BELMONT MIDDLE AND HIGH SCHOOL BUILDING COMMITTEE

SEPTEMBER 11 2019

UPDATED EXTERIOR VE ITEMS

SITE IMPROVEMENTS - REDUCE RETAINING WALLS / WALKWAY AREA AT POND TERRACE

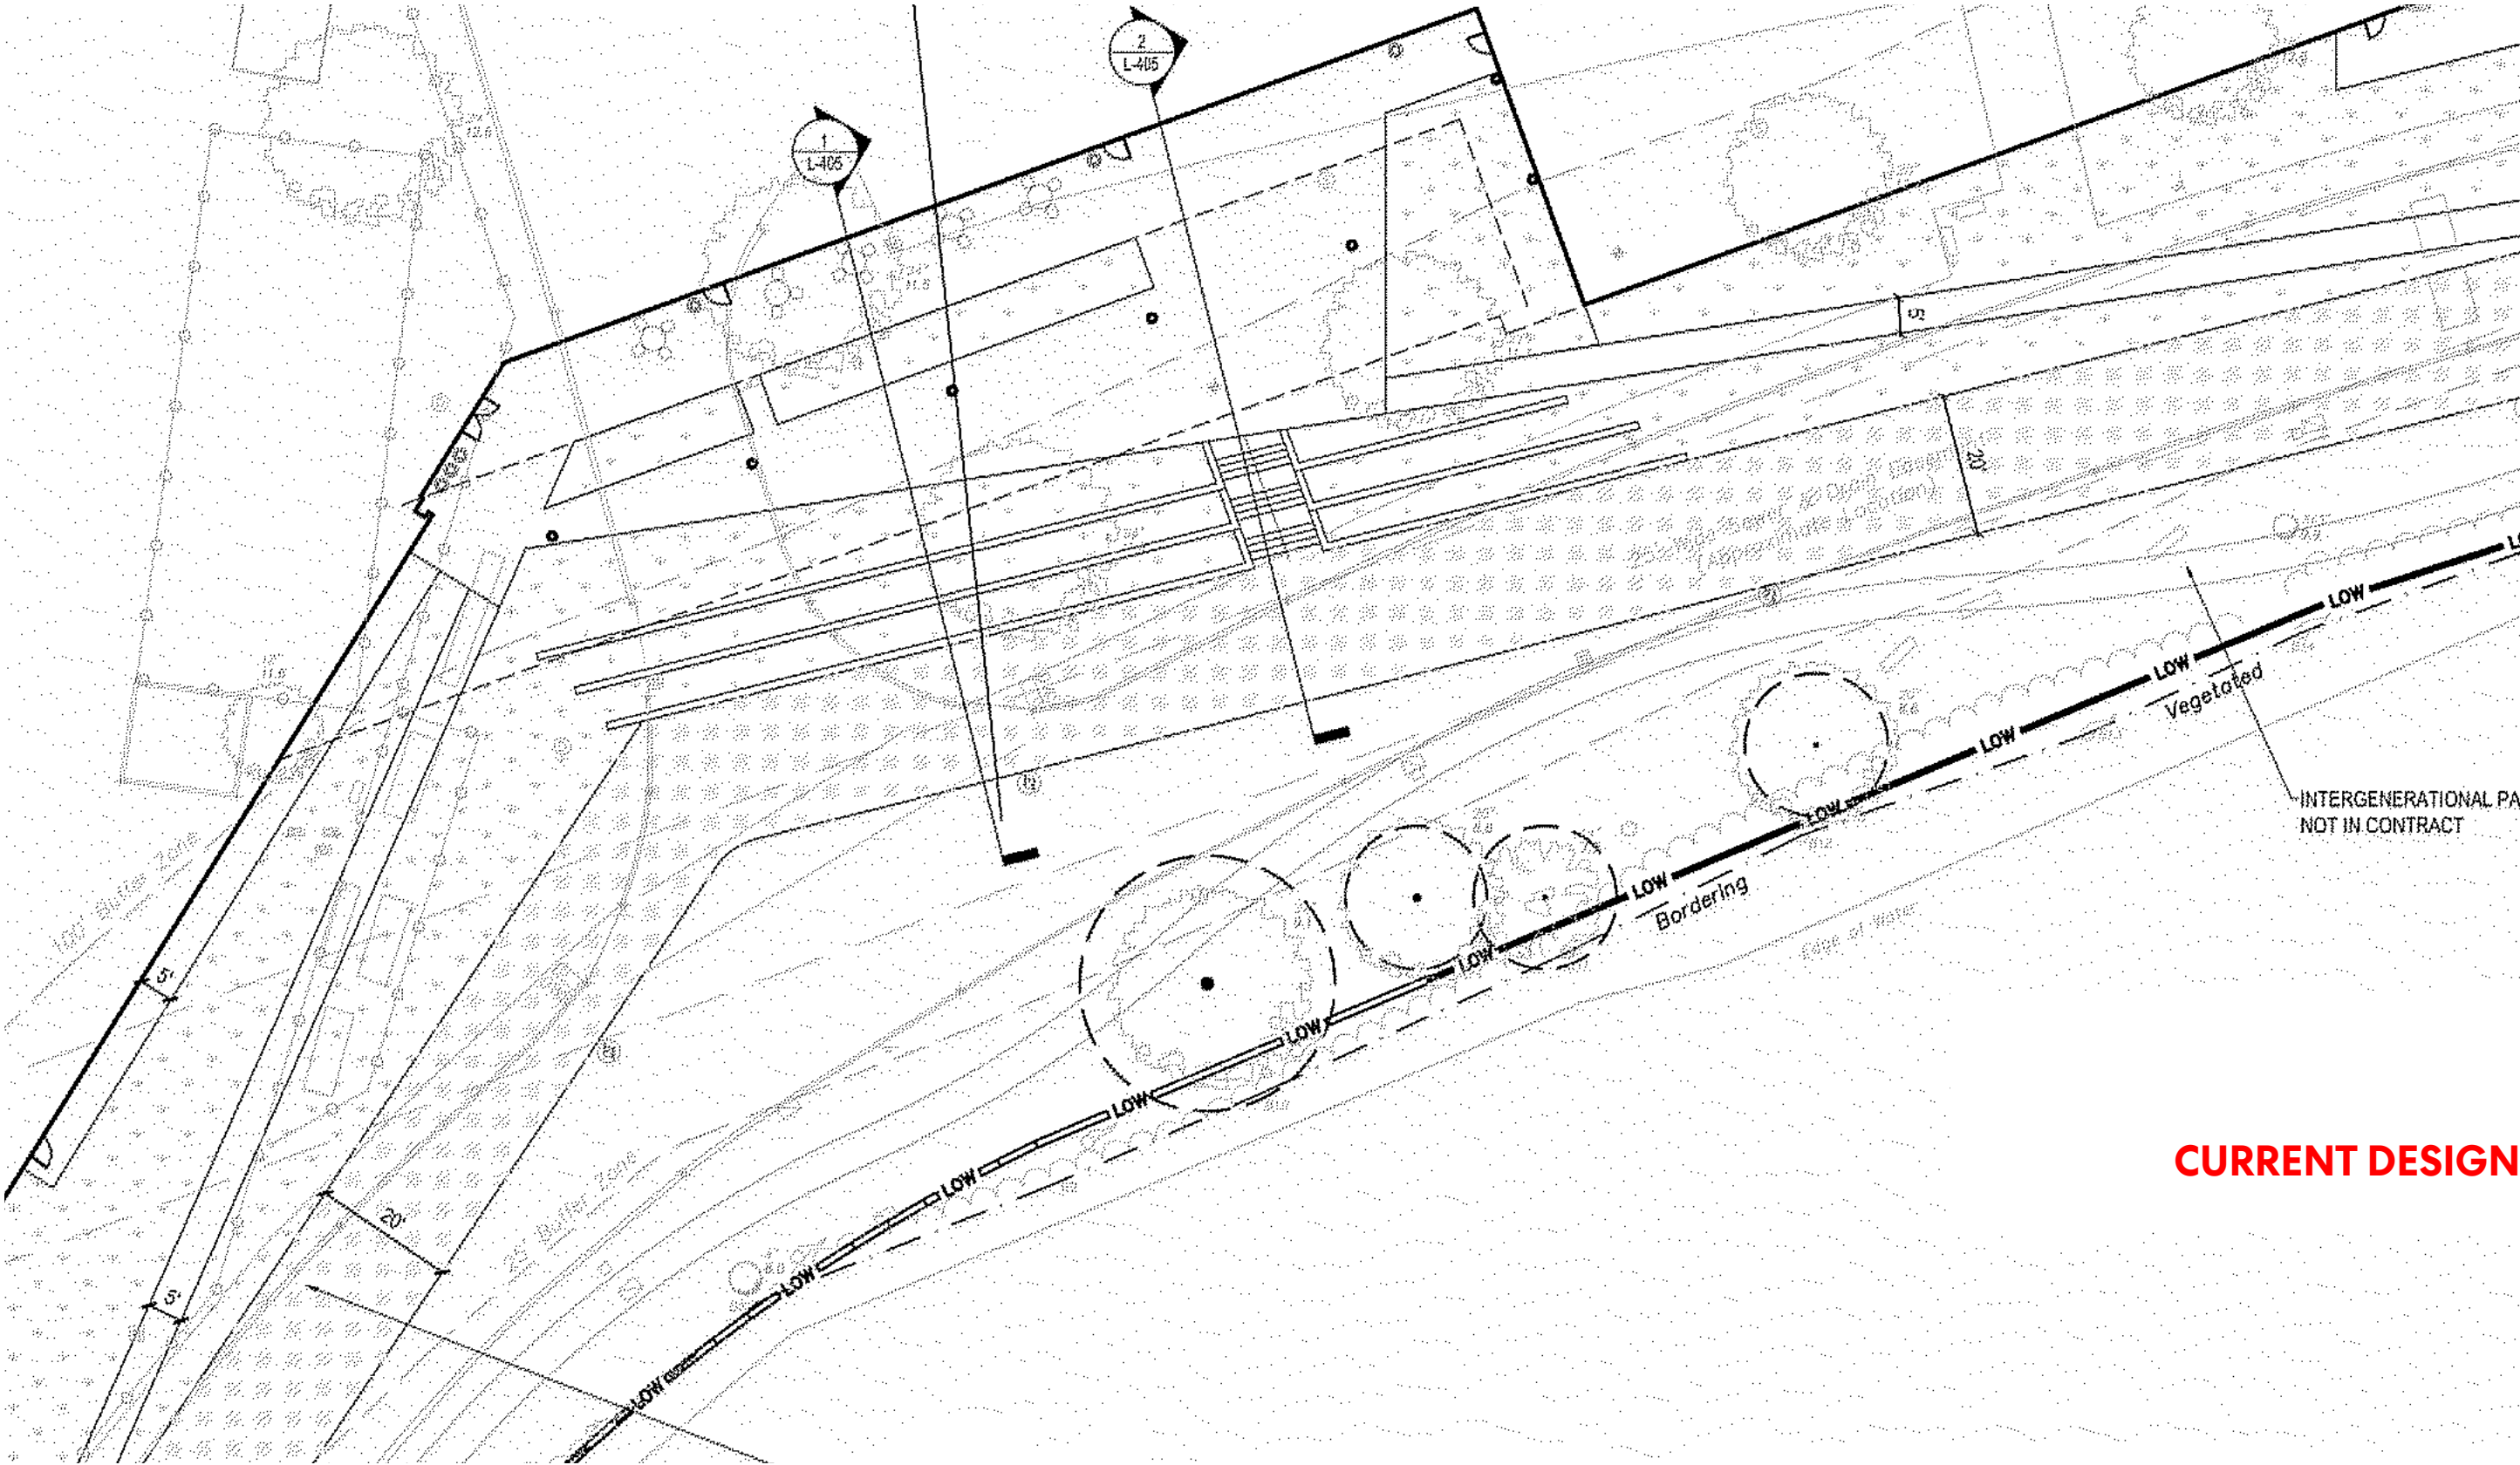
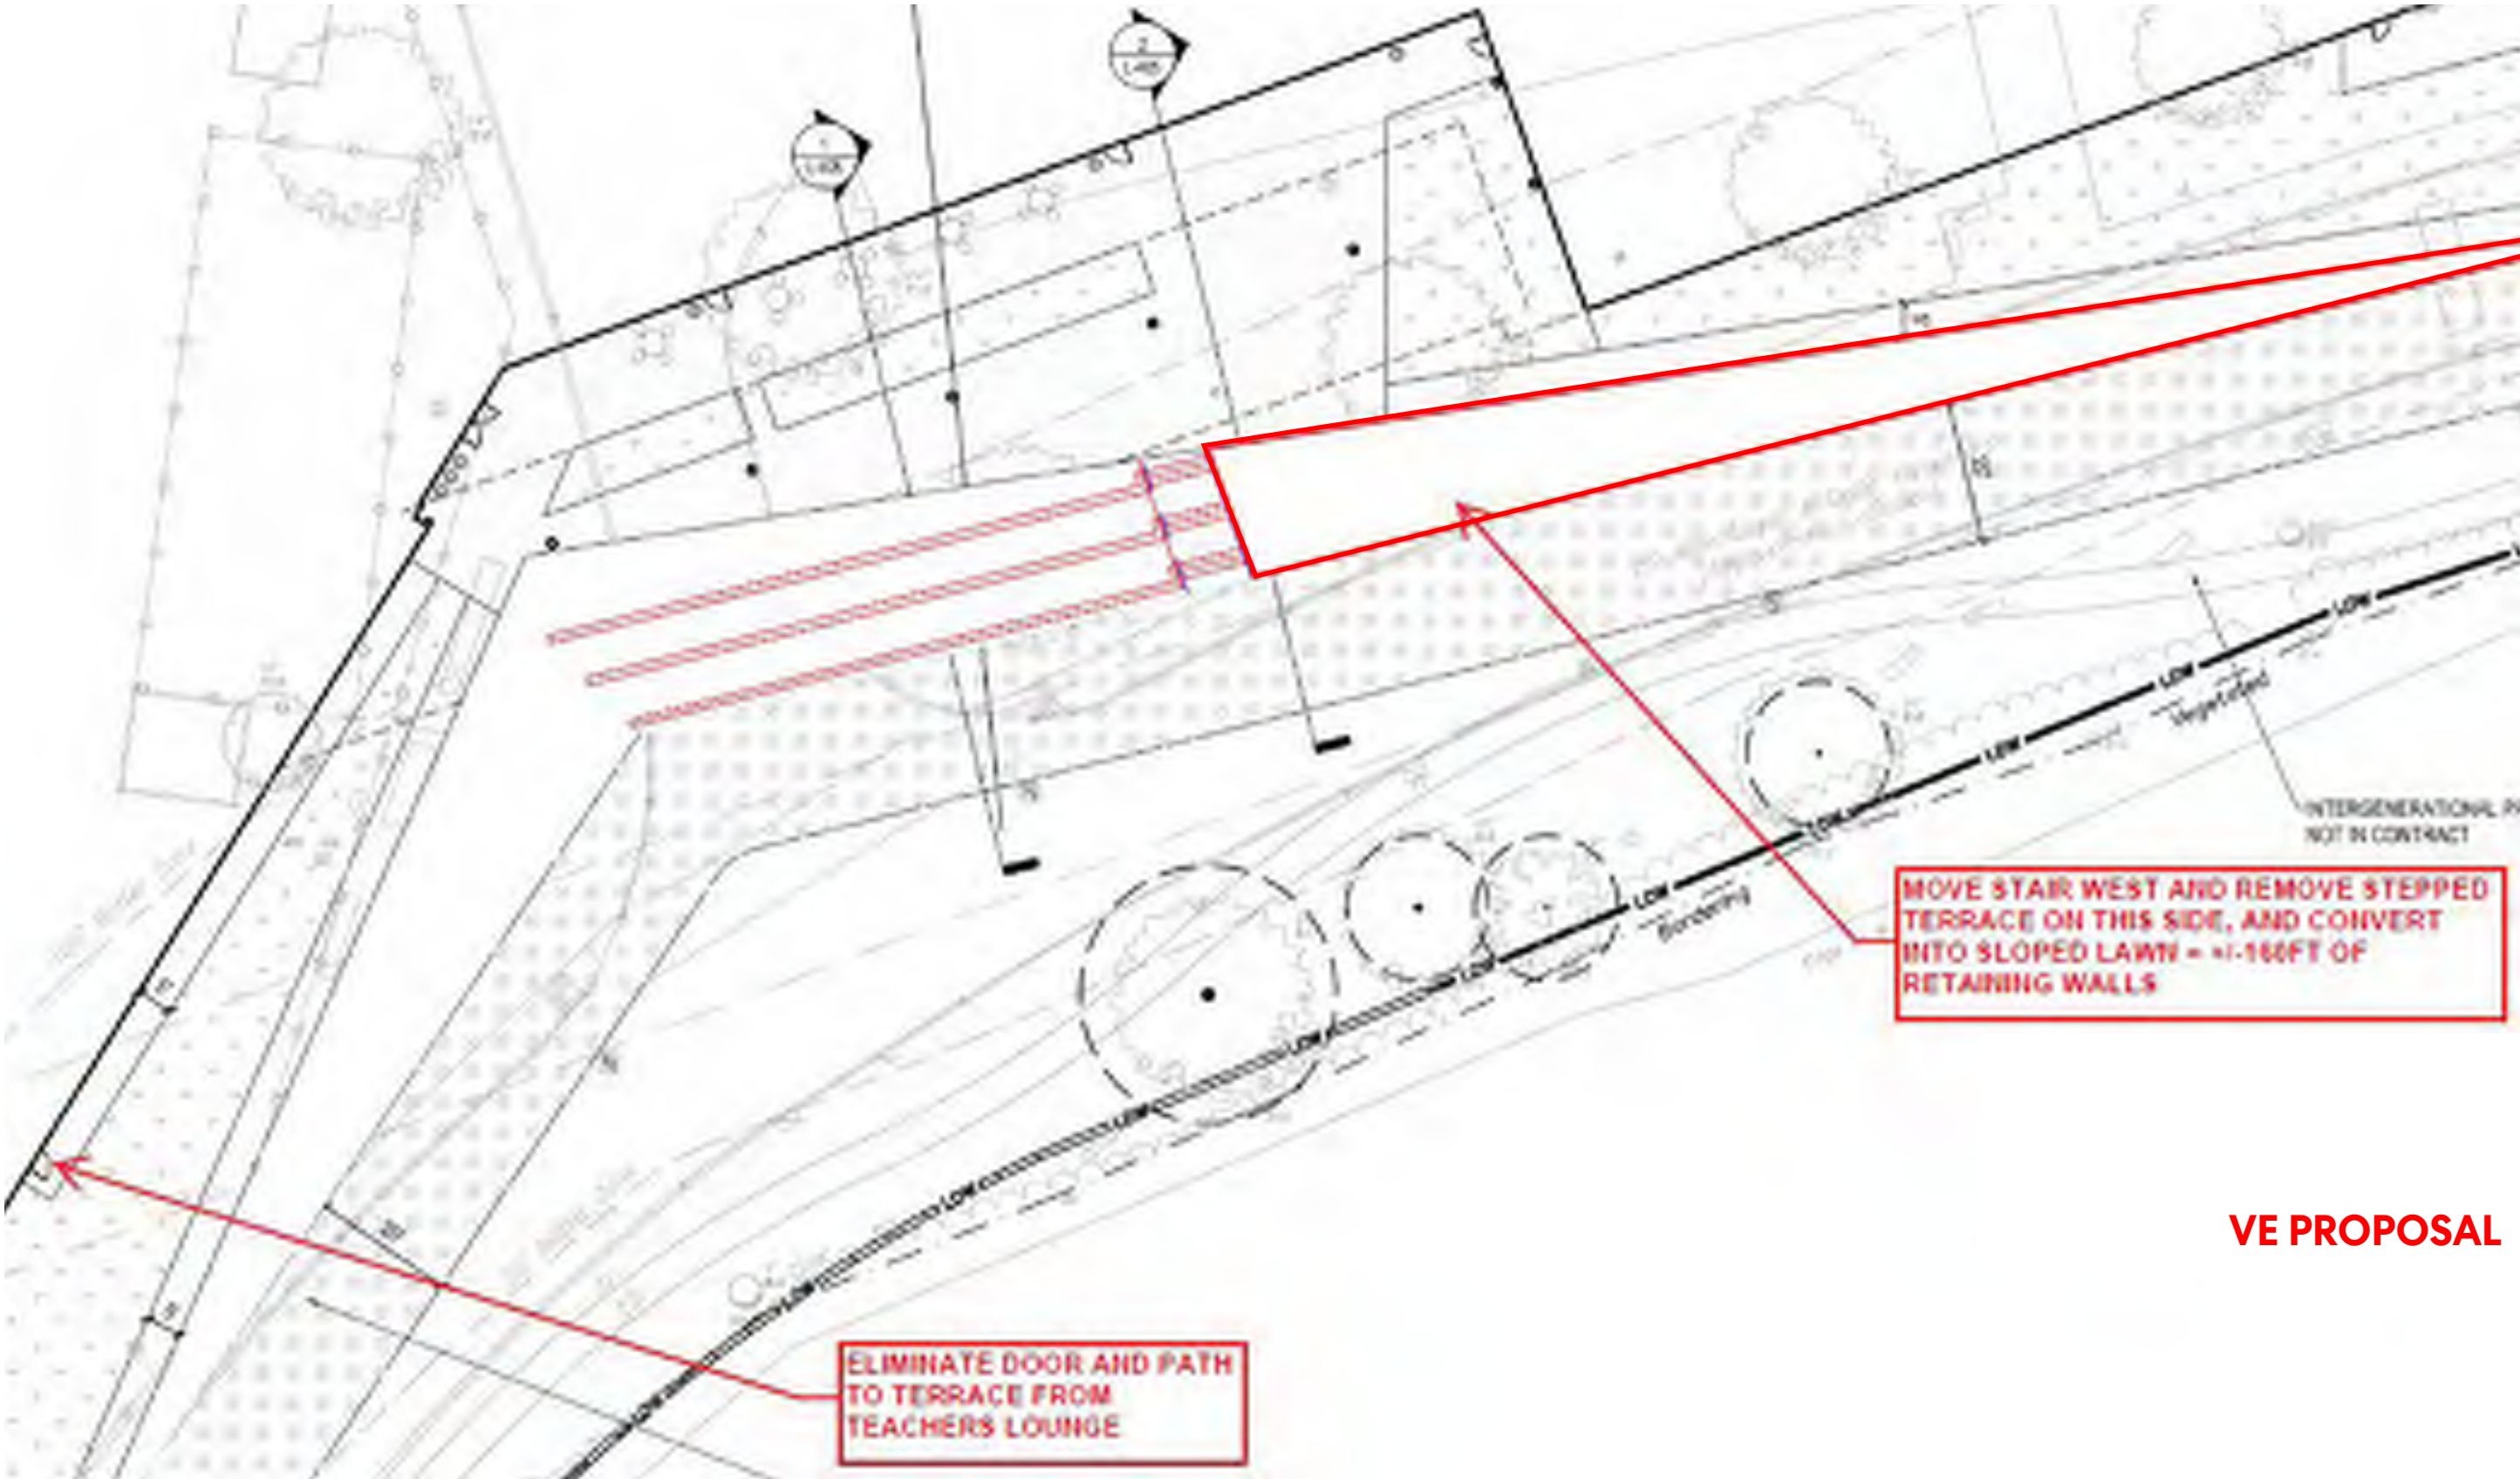
CURRENT DESIGN

VE PROPOSAL

TILE COST REDUCTION STRATEGY

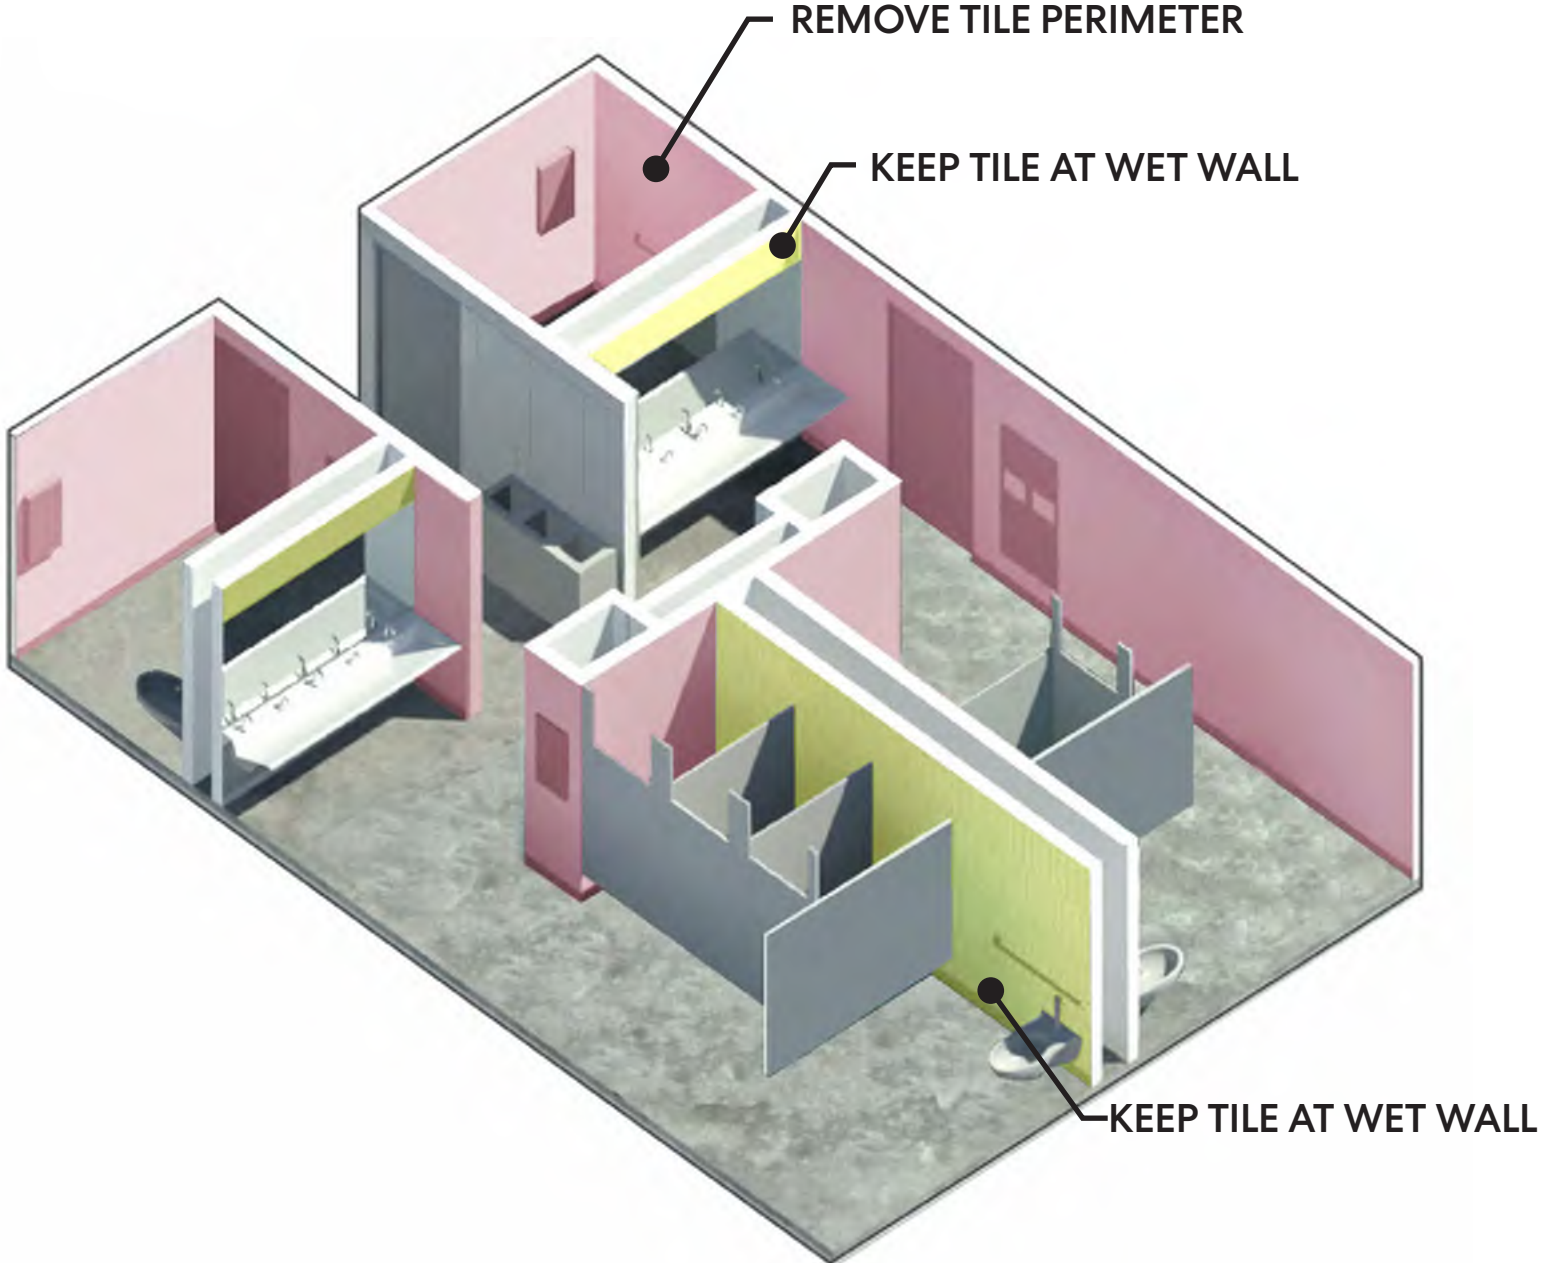
- **REDUCE BATHROOM WALL TILE TO ONLY WET WALLS**
- **REDUCE CORRIDOR TILE HEIGHT TO 4'-6"**
- **ELIMINATE ALL OPERABLE PARTITIONS IN HIGH SCHOOL**
